PART 21 REPORT - DEFECTIVE BARTON DIFFERENTIAL PRESSURE SWITCHES

SUBJECT: Notification of Defect

PRODUCT ADVISORY

Model 288A, 289A, 580A and 581A Differential Pressure Switch Defect

MODEL 288A/289A SWITCH OPERATING MECHANISM MOCKUP
(Model 580A/581A Switch Operating Mechanism is similar)

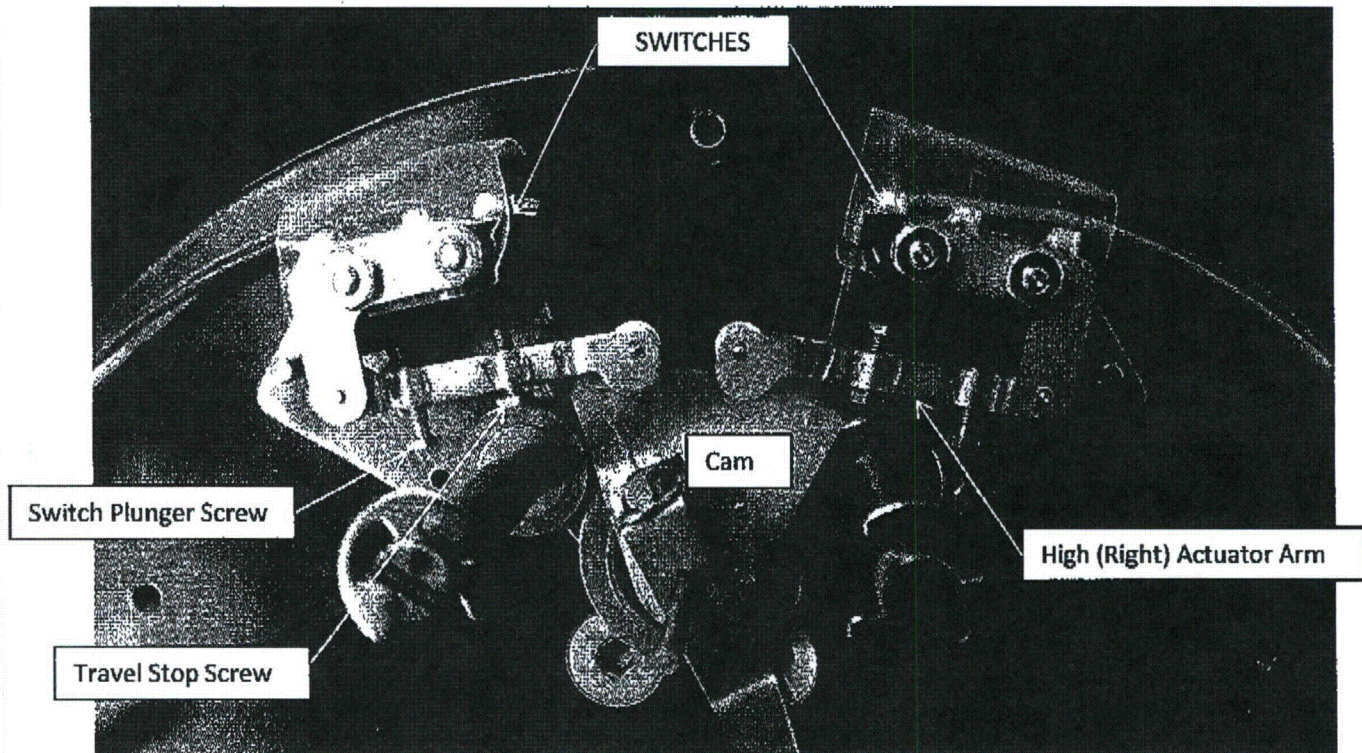
Testing performed to evaluate the significance of the of the non-conforming condition revealed that the force of the miniature switch internal operating features can cause the thread "locking" material to be displaced allowing an undersized plunger screw to change its set position resulting in a change in the point where the switch will actuate (change in contact position). Screws with conforming threads did not demonstrate the same issue. The maximum change in screw position observed during this testing effort equates to a switch set point change of approximately 8.4% of the instrument's factory calibrated span.

Cameron recommends that utilities perform increased switch set point verifications on the instruments affected by this notification. It is not possible to determine which of the switches might have nonconforming switch plunger screws. Therefore, Cameron recommends that new switch actuator arm assemblies be replaced on any unit that is evaluated to be a concern by our customers. These replacement parts are available in the Cameron stock system and will be supplied free of charge for any of the products included within the scope of this notification. The P/N's for the replacement assemblies are identified on the following page.
